Access Compliance Report

Public Rights-of-Way

(Curb Ramps)

Intersection ID: 42359	Main Street: HERON_GLEN_DR	Cross Street: WRENS_NEST_LN	Location:	N
ADA ID: EF0A875FA61D	Ramp Type: PerpDiag	Initial Pass/Fail: Pass	Overall Compliance: No	Severity Score: 10
Codes/Mitigation Info/Possible Solution		Field Measurements/Component Compliance

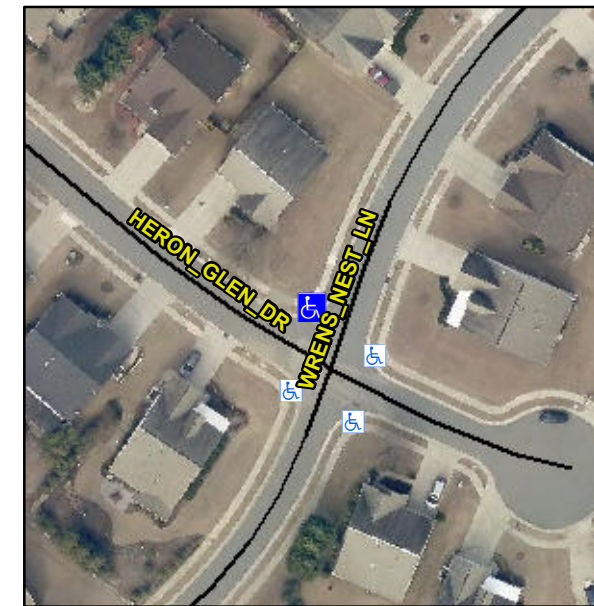
R304.2.2-Perp, R304.3.2-Para, R305

Remove & Replace Curb Ramp With Two New Directional Ramps or Equivalent.
